4410-86-L-0173  
Document ID 0113P

September 26, 1986

Three Mile Island Nuclear Station, Unit 2 (TMI-2)  
Operating License No. DPR-73  
Docket No. 50-320  
Deep-Bed Filters In The DWCS

**CONCEPTUAL ARRANGEMENT FOR  
CONVERSION OF 'KNOCK-OUT' CANISTER  
TO A D.E. FILTER WHICH CAN BE USED  
TO CLEAN UP POOLS & RV**

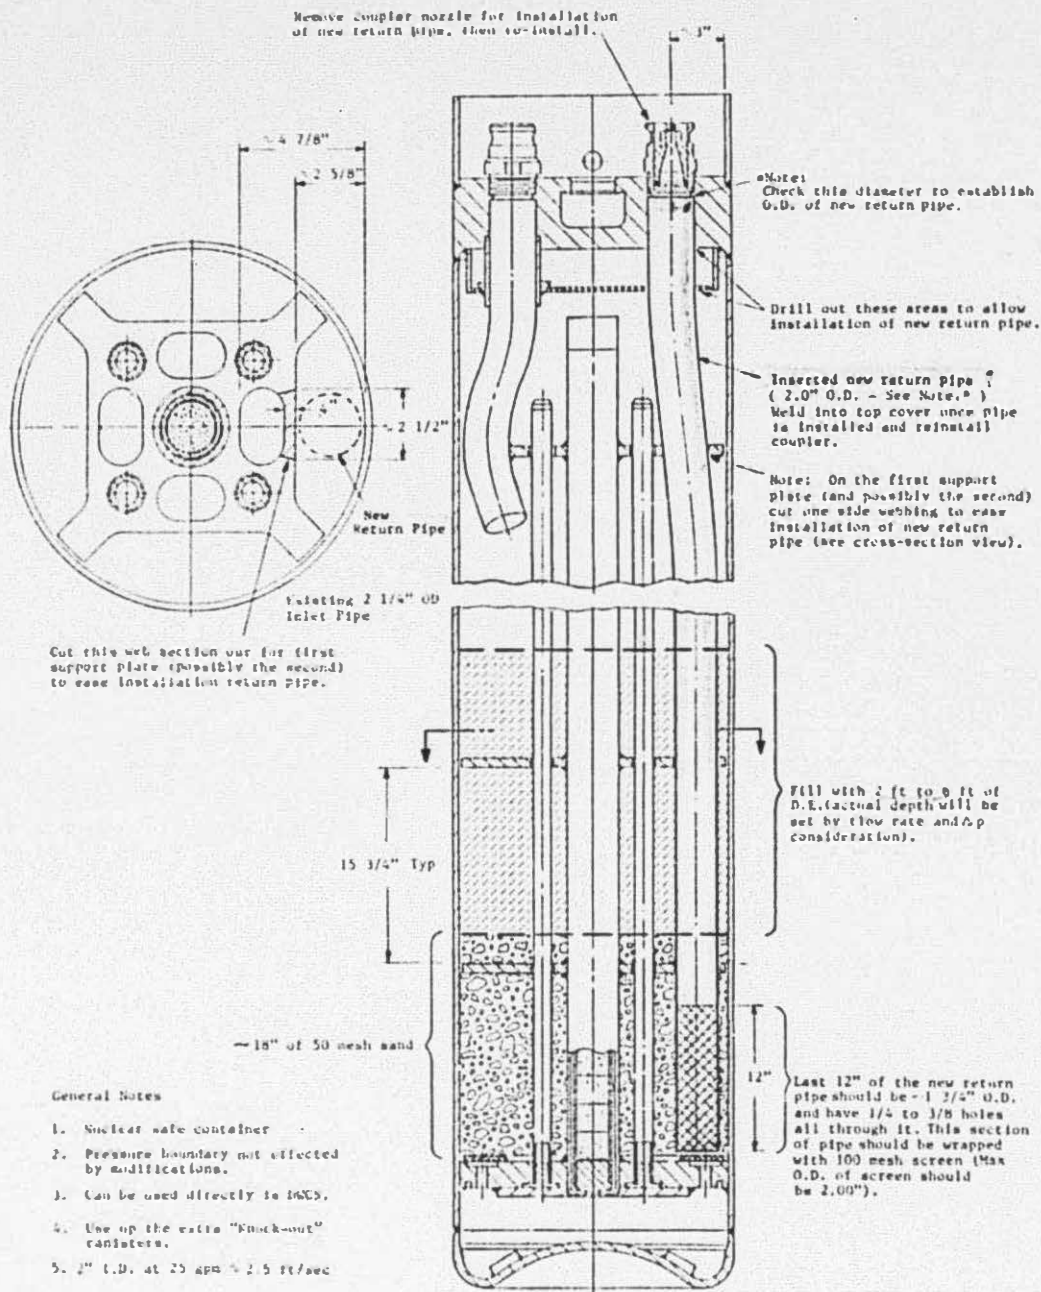
- o Cutting the existing inlet tube below the support ring,
- o Adding a 2" O.D. stainless steel pipe as an outlet tube,
- o Routing the outlet tube through the gap between two legs of the support spiders,
- o Sizing the support ring to accommodate the outlet tube, and
- o Extending the outlet tube down to within 1" of the bottom plate.

The bottom 12" of the extended outlet tube will have multiple 1/4" to 3/8" holes and will be covered with a 100 mesh stainless steel screen. The outlet tube will be attached to one (1) or more support spiders to prevent significant motion of the outlet tube during canister handling. These minor modifications are expected to have no adverse impact on the previous structural evaluations performed on the knock-out canisters. The canister designer is currently reviewing these modifications to confirm this. GPU Nuclear will inform you if any significant deviations to the previous structural evaluations are discovered.
